Access Compliance Report Public Rights-of-Way (Pedestrian Signals)

Main Street: HEWES_AVE Cross Street: SPAULDING_AVE Location: SW

ADA ID: SGAT211015095902 Signal Type: One Push Button-Non APS Overall Compliance: No Severity Scores: BTN 1: 25 BTN 2: N/A No BTN: N/A

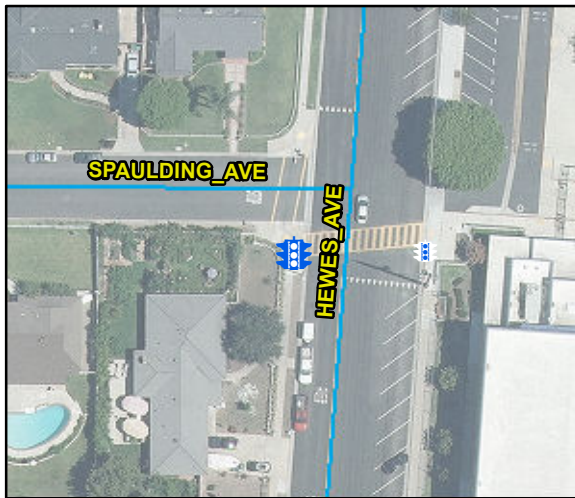
Possible Solutions: Remove and Replace Clear Space.

OC Std/PROW: R404.2, R404.3
